MARK-UP OF SECTION 96 INCLUSIONS

16.07.2015 - 29.07.2016	A	DEVELOPMENT APPLICATION ISSUE SECTION 96 ISSUE	Morris Goding Elisa Moechar Phone: 9692 8000 Email: elisa@mgac.com.au	MDA Australia Damon Bissell Phone: 400 444 410 Email: damon@mda-aust.com.au	Chris Medland Phone: 9437 4611 Email: chris@medlandmetropolis.com.au	Brian Clarke Phone: 9437 4611 Email: brian@wilkinsonmurray.com.au	Tony Henslip Phone: 9211 7777 Email: tony@tmplg.com.au	Glenn Dixon Phone: 9332 3601 Email: glenn@360.net.au	WENONA SCHOOL 176 Walker Street, North Sydney NSW 2060 Phone: 9409 4406 Email: hmckenzie@wenona.nsw.edu.au	WENONA PROJECT ARCHEMEDES 255-265 Miller Street, North Sydney NSW 2060 PROJECT NO : 14010	Tonkin Zulaikha Greer Architects 117 Reservoir Street ABN: 4600272349 P: (02) 9215 4900 F: (02) 9215 4901 EMAIL: matilda@tztg.com.au WEB www.tztg.com.au	LEVEL 6 PLAN SCALES 1:100 @A1 PHASE SECTION 96 DRAWING NO A-1008 REVISION A	ABN, AVDB, JH, MW, SB, SD, CW CHECKED PT

16.07.2015 - 29.07.2016	A	DEVELOPMENT APPLICATION ISSUE SECTION 96 ISSUE	Do not scale off drawings. Use figured dimensions only. Report any discrepancies to the architect. These designs, plans, specifications and the copyright therein a

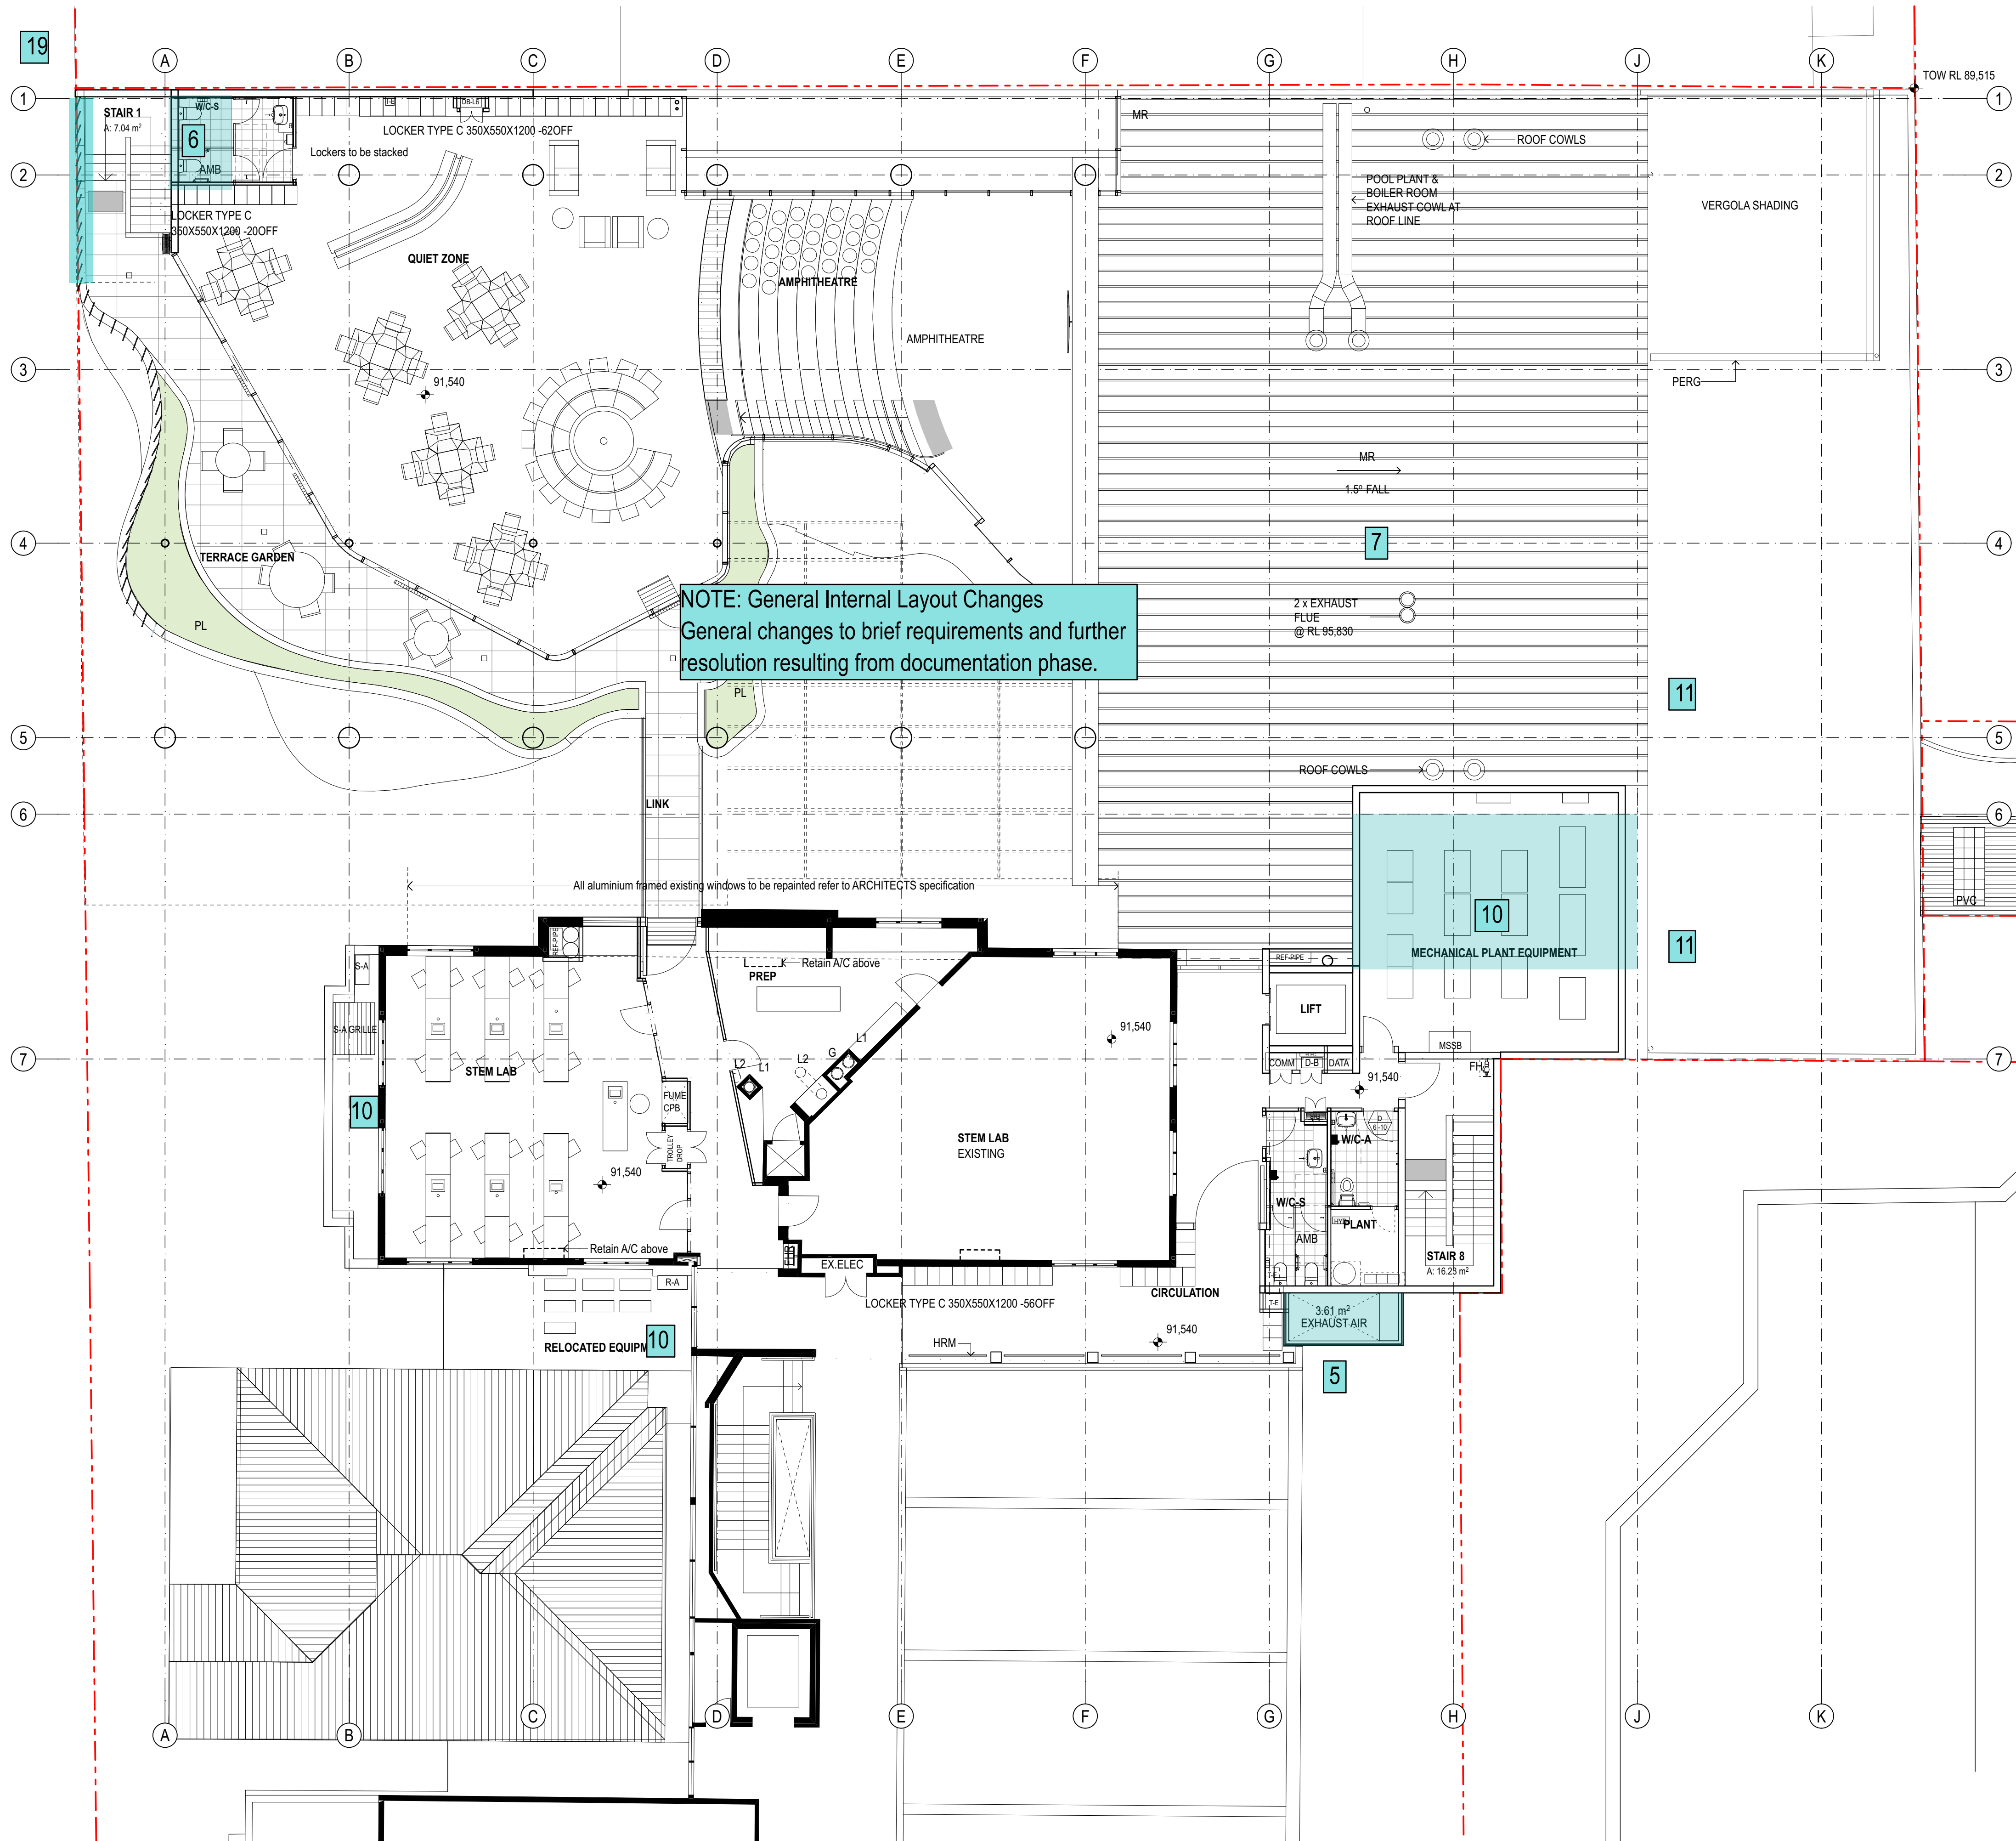
NOTE: General Internal Layout Changes
General changes to brief requirements and further resolution resulting from documentation phase.

- 5** Exhaust Relocation- The location of the pool exhaust has relocated for design enhancement. The proposed relocation will have a positive effect from the public domain as it will not be visible from Elliott Street.

- 6** GFA/FSR Modification - resulting from mechanical design development
- 7** General External Layout Change
 - modification to service locations on roof

- 2° fall as apposed to the approved 3 ° fall
- 10** Increased external plant
 - The requirement to increase the size (approx 40m2).of the external plant to effectively treat the internal loads was a result of detailed design. The increased extent of plant will have a minimal visual impact.

- Additional outdoor air units required relocation during detail design phase when staging was assessed in more detail. These are proposed to be located with other existing units out of lines of sight.

- 11** Retractable shading removed
- 19** The extent of glass louvres on the facade has reduced due to practical considerations regarding maintenance, build-ability and cost

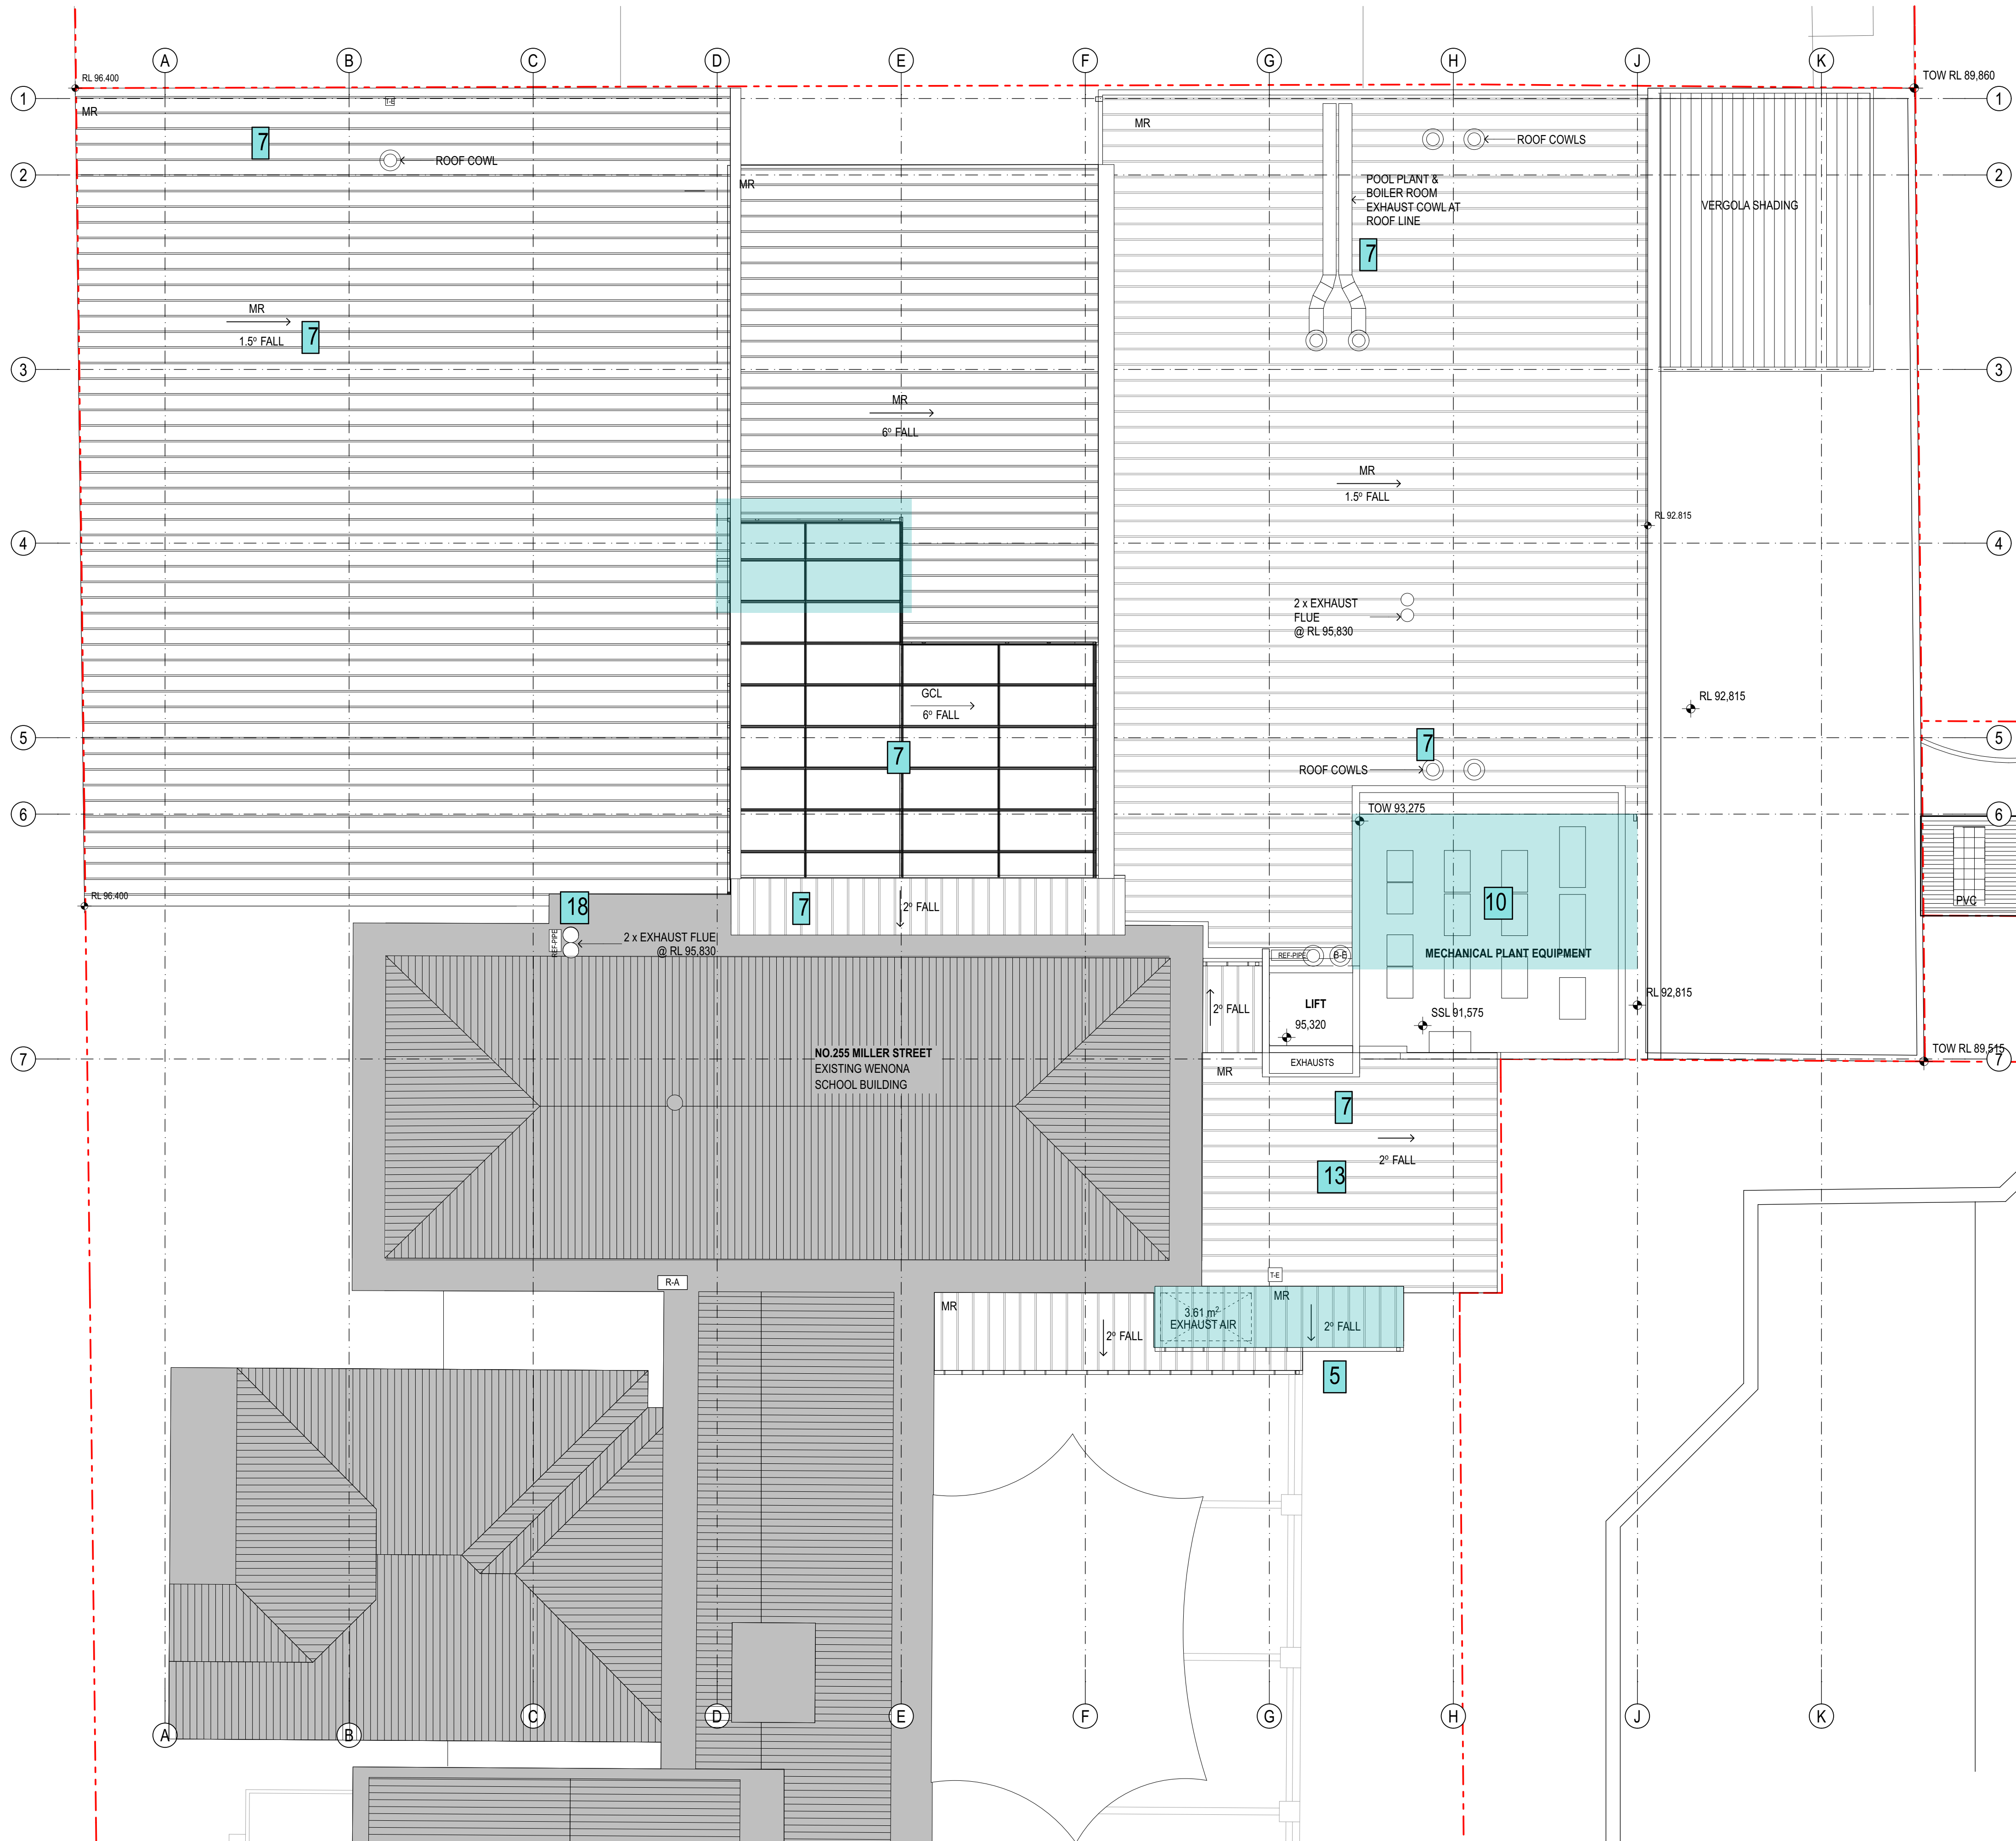
- 5** Exhaust Relocation- The location of the pool exhaust has been relocated for design enhancement. The proposed relocation will have a positive effect from the public domain as it will not be visible from Elliott Street.

- 7** General External Layout Change
 - modification of the shape of the glass roof due to detailed design resolution.
 - Additional roof required to weatherproof between the existing and new buildings at the roof line.

- General changes to roof cowl locations and exhausts due to detailed design resolution
 - 1.5° fall as apposed to the approved 2 ° fall
- 10** Increased external plant

- The requirement to increase the size (approx 40m2) of the external plant to effectively treat the internal loads was a result of detailed design. The increased extent of plant will have a minimal visual impact.

- Additional relocated outdoor air units required during detail design phase when staging was assessed in more detail.
- 13** Modification to roof type & pitch due to detail design resolution.

- 18** Relocation of kitchen exhaust due to detailed design resolution.

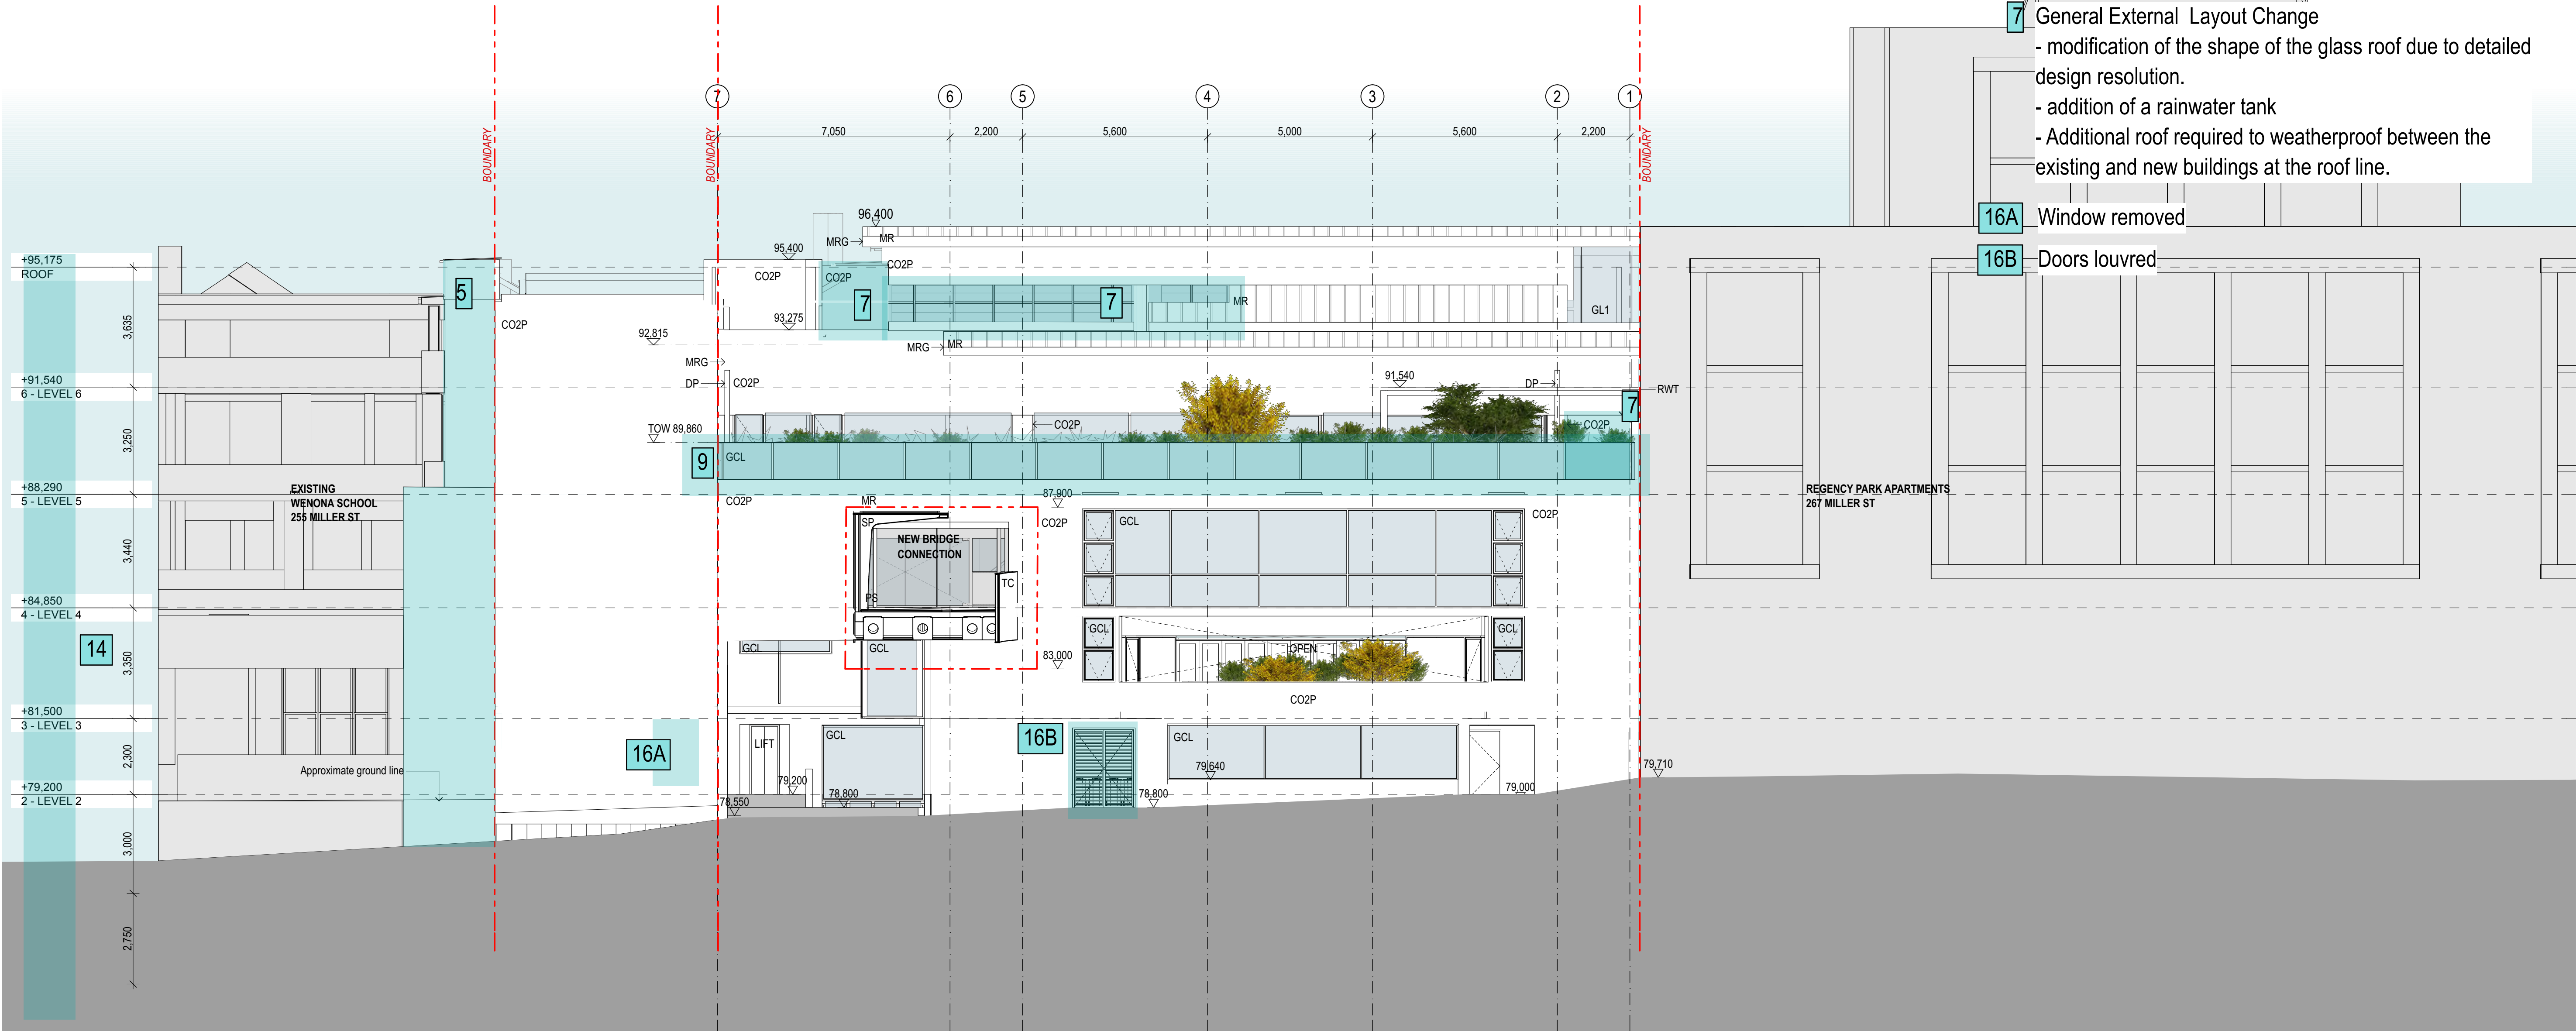
- 14
- RL's for floor levels adjusted due to updated survey information on existing building floor levels
- 5
- Exhaust Relocation- The location of the pool exhaust has relocated for design enhancement. The proposed relocation will have a positive effect from the public domain as it will not be visible from Elliott Street.
- 9
- Change to Balustrade
- Change from 1100mm high concrete balustrade to 450mm high concrete planter wall with 1100mm height glass balustrade. Top of Wall height now 89.860
- 7
- General External Layout Change
- modification of the shape of the glass roof due to detailed design resolution.
- addition of a rainwater tank
- Additional roof required to weatherproof between the existing and new buildings at the roof line.
- 16A
- Window removed
- 16B
- Doors louvred
